ZONING CHANGE REVIEW SHEET

CASE: C14-2019-0129 – 10801 Wayne Riddell Loop

SUBJECT: C14-2019-0129
10801 Wayne Riddell Loop (District 5)
Response to ZAP Recommendation

1. Supported Alternative Cross-section for the Wayne Riddell Loop extension

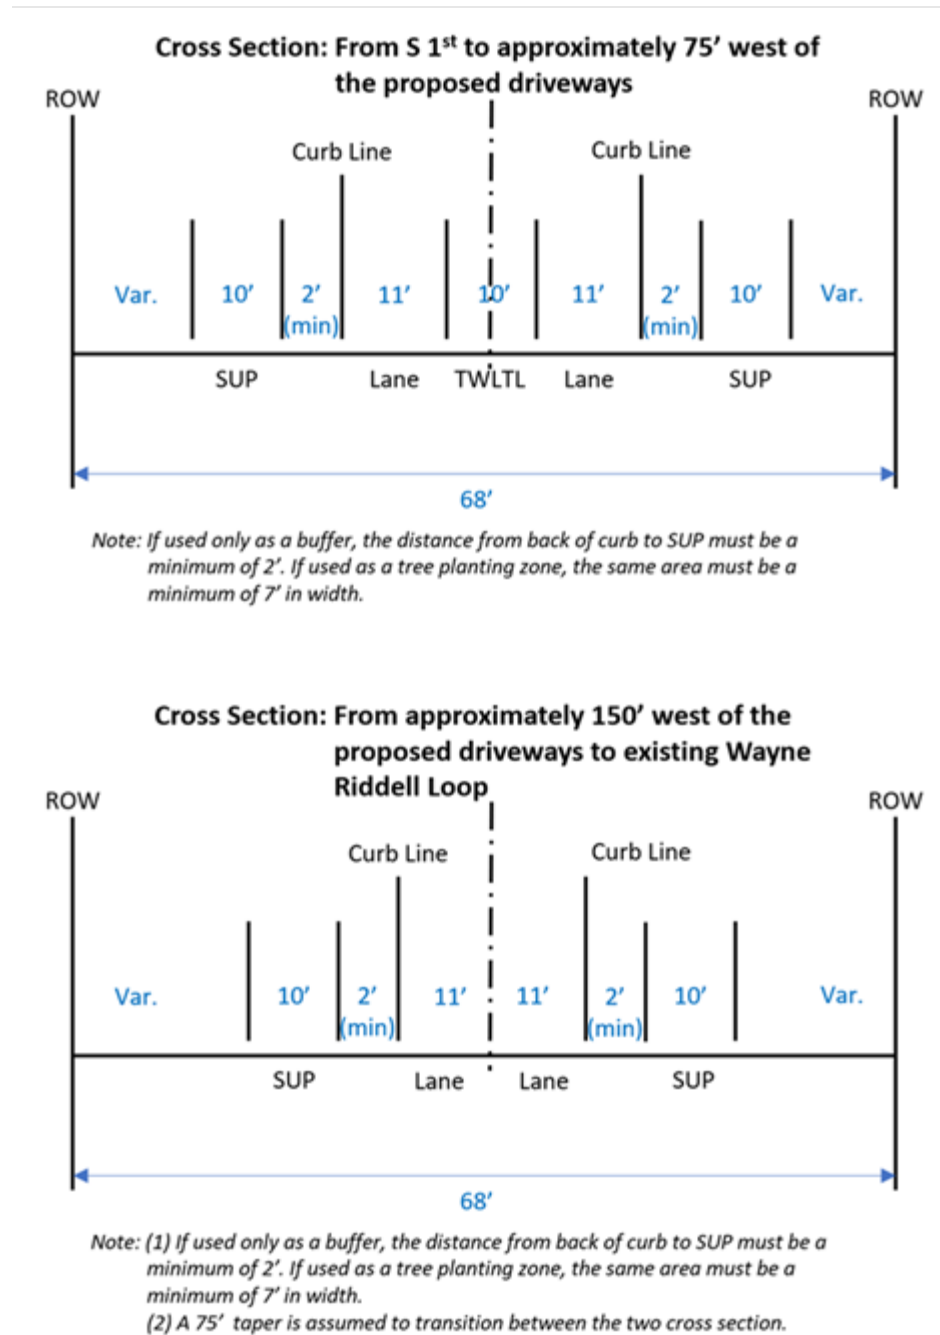
- Between existing Wayne Riddell Loop and South First Street access, a revised cross section will include an eastbound and westbound 11' travel lane. Both lanes will be surrounded by a 10' pervious shared use path. In total, the cross-section will include these two 10' shared use paths and two 11' travel lanes.
- At South First Street access, cross section will include an additional left turn lane. Cross section will include an 11' travel lane, 11' left turn lane and an 11' travel lane.
- Vehicle speeds on this project's newly dedicated Wayne Riddell Loop right of way are restricted to 20 mph.

Staff supports ZAP’s alternative cross-section within the required dedication of 68-ft with the exception that the center turn lane at site’s driveways be reduced to 10-ft (from 11-ft) and that a minimum 2-ft buffer be added between the back of curb and the shared-use path. The buffer may be increased to 7-ft for the required planting zone. Exhibit 1 below depicts the recommended cross-section.
